<b>Title - Sujet</b> BOW THRUSTER SYSTEM	
<b>Solicitation No. - N° de l'invitation</b> F7049-150111/A	<b>Amendment No. - N° modif.</b> 002
<b>Client Reference No. - N° de référence du client</b> F7049-150111	<b>Date</b> 2015-10-07
<b>GETS Reference No. - N° de référence de SEAG</b> PW-\$\$ML-035-25363	
<b>File No. - N° de dossier</b> 035ml.F7049-150111	<b>CCC No./N° CCC - FMS No./N° VME</b>
<b>Solicitation Closes - L'invitation prend fin</b> <b>at - à 02:00 PM</b> <b>on - le 2015-10-27</b>	<b>Time Zone</b> <b>Fuseau horaire</b> Eastern Daylight Saving Time EDT
<b>F.O.B. - F.A.B.</b> <b>Plant-Usine:</b> <input type="checkbox"/> <b>Destination:</b> <input checked="" type="checkbox"/> <b>Other-Autre:</b> <input type="checkbox"/>	
<b>Address Enquiries to: - Adresser toutes questions à:</b> Tinkess, Dianne	<b>Buyer Id - Id de l'acheteur</b> 035ml
<b>Telephone No. - N° de téléphone</b> (819) 956-0178 ( )	<b>FAX No. - N° de FAX</b> (819) 956-0897

**This solicitation amendment 002 is raised to provide this question and answer set 1 and to provide attached drawings.**

**Question and Answer Set 1**

MARINE INDUSTRIES LIMITED  
NAVAT TYPE 100  
HULL 450-451  
STEEL WING CONSOLE  
SCHEMATIC DIAGRAM

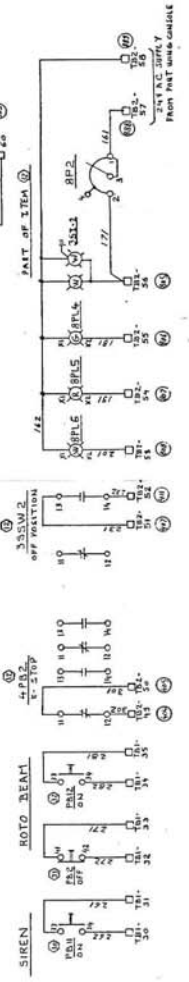
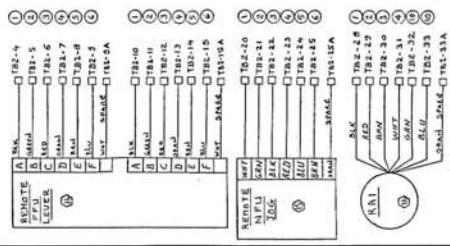
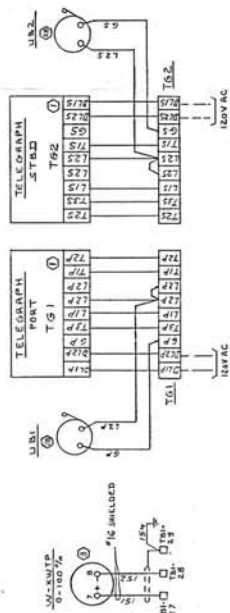
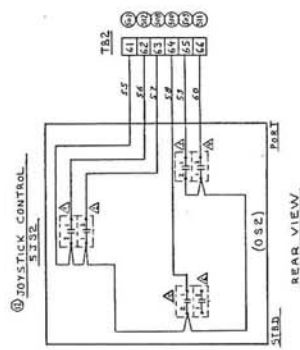
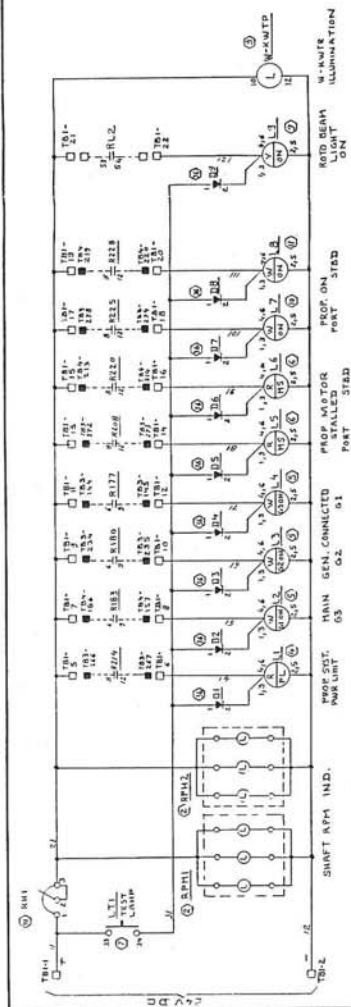
Do we need to integrate the bridge controls to fit the existing consoles?

Yes the controls must fit within the existing footprints. CCG may renew or replace the existing consoles, but nonetheless, the existing footprint is to be retained. See attached Drawings:

- 1a) M7066D-325A1 Port Wing & Stbd Wing Console General Arrangement
- 1b) M7066D-326A1 Port Wing Console Schematic Diagram
- 1c) M7066D-328A1 Stbd Wing Console Schematic Diagram
